PCI-SIG ENGINEERING CHANGE REQUEST

TITLE:	Hot Plug
DATE:	24 June 2004 [Updated 12 July 2004]
AFFECTED DOCUMENT:	PCI Express Base Specification Revision 1.0a
SPONSOR:	Mohan Kumar & David Harriman, Intel Corporation Dave Walker, Microsoft Carl Jackson, HP

Figure 7-13: Device Capabilities Register

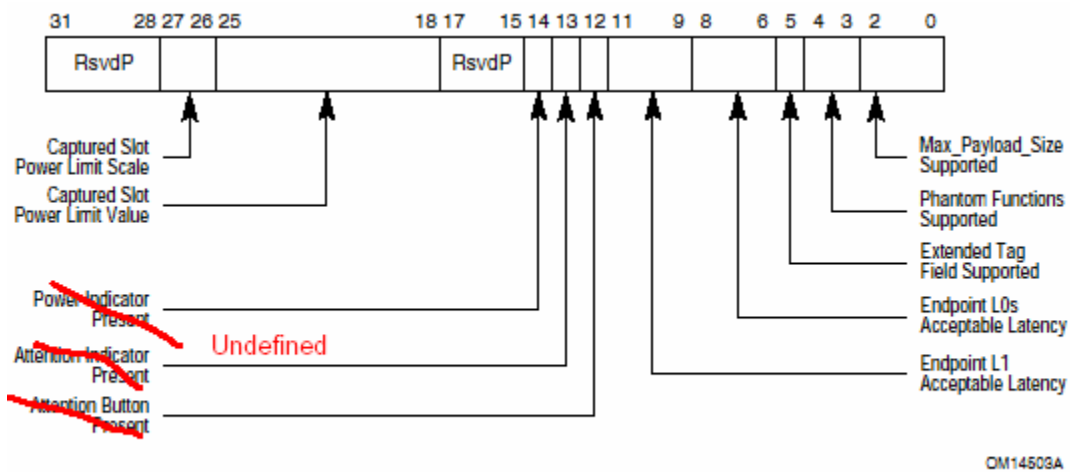
Bit Location	Register Description	Attributes
...		
12	<p>The value read from this bit is undefined. In previous versions of this specification, this bit was used to indicate that an Attention Button is implemented on the adapter and electrically controlled by the component on the adapter. System software must ignore the value read from this bit. System software is permitted to write any value to this bit. Attention Button Present—When set to 1b, this bit indicates that an Attention Button is implemented on the adapter and is electrically controlled by the component on the adapter. Attention Button press events are reported using the Attention_Button_Pressed Message. This bit is valid for the following PCI Express device Types:</p> <ul style="list-style-type: none"> • PCI Express Endpoint device • Legacy PCI Express Endpoint device • Upstream Port of PCI Express Switch • PCI Express to PCI/PCI X Bridge 	RO

Bit Location	Register Description	Attributes
13	<p>The value read from this bit is undefined. In previous versions of this specification, this bit was used to indicate that an Attention Indicator is implemented on the adapter and electrically controlled by the component on the adapter. System software must ignore the value read from this bit. System software is permitted to write any value to this bit. Attention Indicator Present—When set to 1b, this bit indicates that an Attention Indicator is implemented on the adapter and is electrically controlled by the component on the adapter using the Attention_Indicator_On, Attention_Indicator_Blink, and Attention_Indicator_Off Messages.</p> <p>This bit is valid for the following PCI Express device Types:</p> <ul style="list-style-type: none"> • PCI Express Endpoint device • Legacy PCI Express Endpoint device • Upstream Port of PCI Express Switch • PCI Express to PCI/PCI-X Bridge 	RO

14	<p>The value read from this bit is undefined. In previous versions of this specification, this bit was used to indicate that a Power Indicator is implemented on the adapter and electrically controlled by the component on the adapter. System software must ignore the value read from this bit. System software is permitted to write any value to this bit. Power Indicator Present—When set to 1b, this bit indicates that a Power Indicator is implemented on the adapter and is electrically controlled by the component on the adapter using the Power_Indicator_On, Power_Indicator_Blink, and Power_Indicator_Off Messages.</p> <p>This bit is valid for the following PCI Express device Types:</p> <ul style="list-style-type: none"> • PCI Express Endpoint device • Legacy PCI Express Endpoint device • Upstream Port of PCI Express Switch • PCI Express to PCI/PCI-X Bridge 	RO
...

Figure 7-19: Slot Capabilities Register

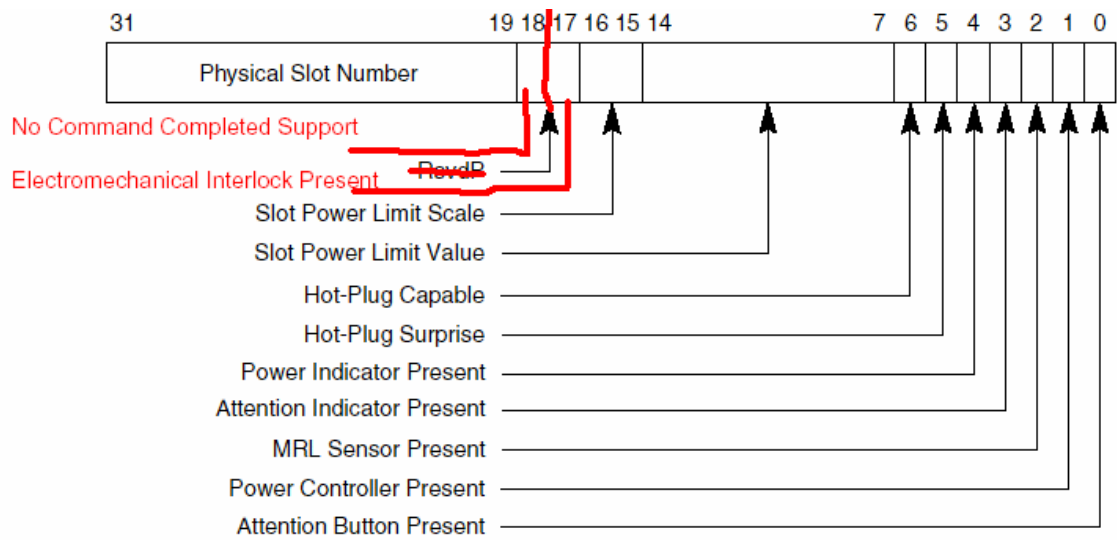
Bit Location	Register Description	Attributes
...		
17	Electromechanical Interlock Present – When set to 1b, this bit indicates that an Electromechanical Interlock is implemented on the chassis for this slot.	HwInit
18	No Command Completed Support – When set to 1b, this bit indicates that this slot does not generate software notification when an issued command is completed by the Hot-Plug Controller. This bit is only permitted to be set to 1b if the hot-plug capable port is able to accept writes to all fields of the Slot Control register without delay between successive writes.	HwInit
...

Figure 7-20: Slot Control Register

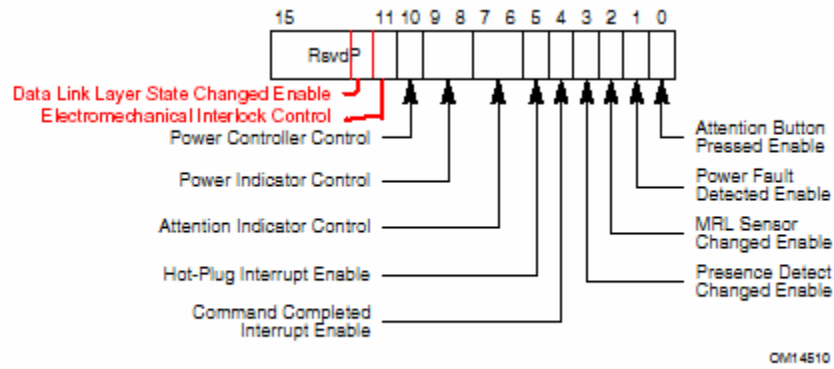
Bit Location	Register Description	Attributes
0	Attention Button Pressed Enable – When set to 1b, this bit enables software notification on an attention button pressed event. See Section 6.7.7. Software may set this bit even if the Attention Button Supported bit in the Slot Capabilities register is 0b, so that Attention Button Pressed messages can cause software notification. Default value of this field is 0b.	RW
...		
4	Command Completed Interrupt Enable – If Command Completed notification is supported (as indicated by No Command Completed Support field of Slot Capabilities Register), When set to 1b, this bit enables software notification when a hot-plug command is completed by the Hot-Plug Controller. Default value of this field is 0b. If Command Completed notification is not supported this bit must be hardwired to 0b.	RW
...

Bit Location	Register Description	Attributes								
7:6	<p>Attention Indicator Control – If an Attention Indicator is implemented, writes to this field set the Attention Indicator to the written state.</p> <p>Reads of this field must reflect the value from the latest write, even if the corresponding hot-plug command is not complete, unless software issues a write without waiting for the previous command to complete in which case the read value is undefined.</p> <p>If the indicator is electrically controlled by chassis, the indicator is controlled directly by the downstream port through implementation specific mechanisms. If the indicator is electrically controlled by the adapter, the indicator is indirectly controlled by transmission of the appropriate Attention Indicator Message (determined by the value written). Regardless of the location of the indicator, the downstream port must transmit the appropriate Attention Indicator Message.</p> <p>Defined encodings are:</p> <table><tr><td>00b</td><td>Reserved</td></tr><tr><td>01b</td><td>On</td></tr><tr><td>10b</td><td>Blink</td></tr><tr><td>11b</td><td>Off</td></tr></table> <p>Note: The default value of this field must be one of the non-Reserved values.</p>	00b	Reserved	01b	On	10b	Blink	11b	Off	RW

00b	Reserved									
01b	On									
10b	Blink									
11b	Off									
9:8	<p>Power Indicator Control – If a Power Indicator is implemented, writes to this field set the Power Indicator to the written state.</p> <p>Reads of this field must reflect the value from the latest write, even if the corresponding hot-plug command is not complete, unless software issues a write without waiting for the previous command to complete in which case the read value is undefined.</p> <p>If the indicator is electrically controlled by chassis, the indicator is controlled directly by the downstream port through implementation specific mechanisms. If the indicator is electrically controlled by the adapter, the indicator is indirectly controlled by transmission of the appropriate Power Indicator Message (determined by the value written). Regardless of the location of the indicator, the downstream port must transmit the appropriate Power Indicator Message.</p> <p>Defined encodings are:</p> <table><tr><td>00b</td><td>Reserved</td></tr><tr><td>01b</td><td>On</td></tr><tr><td>10b</td><td>Blink</td></tr><tr><td>11b</td><td>Off</td></tr></table> <p>Note: The default value of this field must be one of the non-Reserved values.</p>	00b	Reserved	01b	On	10b	Blink	11b	Off	RW

00b	Reserved									
01b	On									
10b	Blink									
11b	Off									
...										
<u>11</u>	<p><u>Electromechanical Interlock Control</u> – If an <u>Electromechanical Interlock</u> is implemented, a write of 1b to this field causes the state of the interlock to toggle. A write of 0b to this field has no effect. A read to this register always returns a 0.</p>	<u>RW</u>								
<u>12</u>	<p><u>Data Link Layer State Changed Enable</u> – If the <u>Data Link Layer Link Active</u> capability is implemented, when set to 1b, this field enables software notification when <u>Data Link Layer Link Active</u> field is changed</p>	<u>RW</u>

Figure 7-21: Slot Status Register

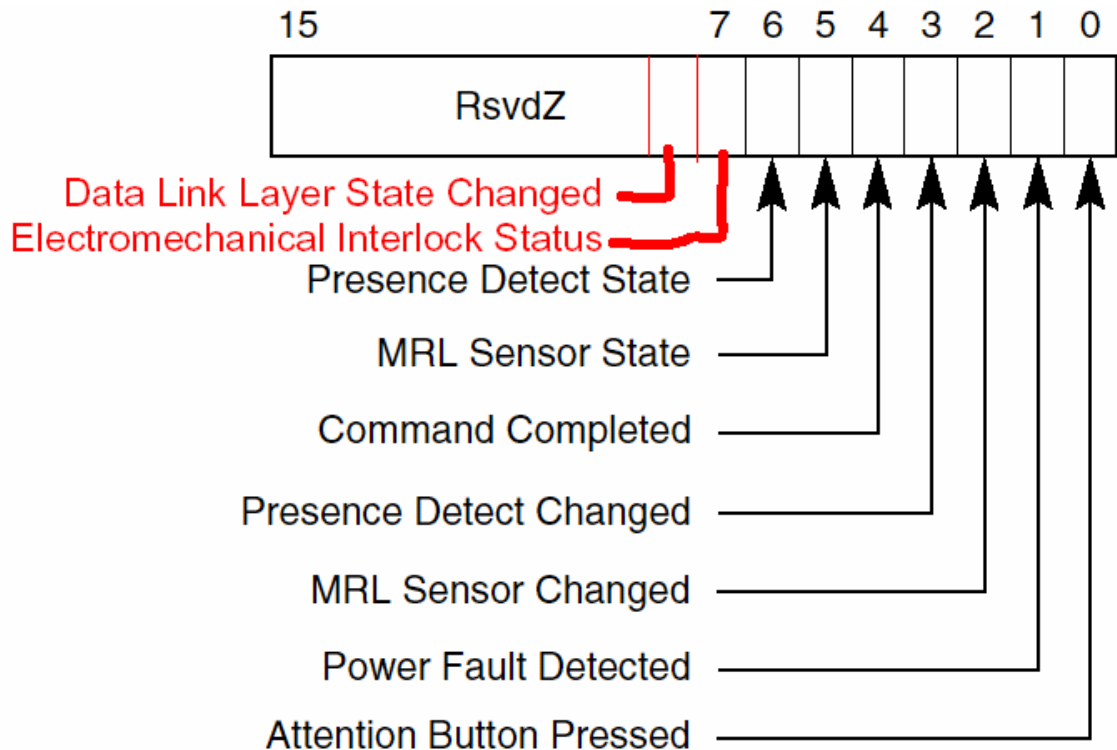
Bit Location	Register Description	Attributes
0	Attention Button Pressed – If an Attention Button is implemented, this bit is set when the attention button is pressed (either as directly detected or by the receipt of an Attention_Button_Pressed Message) . If an Attention Button is not supported and the form factor does not support the Attention_Button_Pressed Message , this bit must not be set.	RW1C
...

Bit Location	Register Description	Attributes
4	Command Completed – If Command Completed notification is supported (as indicated by No Command Completed Support field of Slot Capabilities Register) , this bit is set when a hot-plug command has completed and the Hot-Plug Controller is ready to accept a subsequent command. The Command Completed status bit is set as an indication to host software that the Hot-Plug Controller has processed the previous command and is ready to receive the next command; it provides no guarantee that the action corresponding to the command is complete. If Command Completed notification is not supported, this bit must be hardwired to 0b.	RW1C
...		
<u>7</u>	Electromechanical Interlock Status – If an Electromechanical Interlock is implemented, this bit indicates the current status of the Electromechanical Interlock. Defined encodings are: 0b Electromechanical Interlock Disengaged 1b Electromechanical Interlock Engaged	<u>RO</u>

<u>8</u>	Data Link Layer State Changed - This bit is set when the value reported in Data Link Layer Link Active field of the Link Status register is changed In response to a Data Link Layer State Changed event, software must read Data Link Layer Link Active field of the Link Status register to determine if the link is active before initiating configuration cycles to the hot plugged device.	<u>RW1C</u>
...
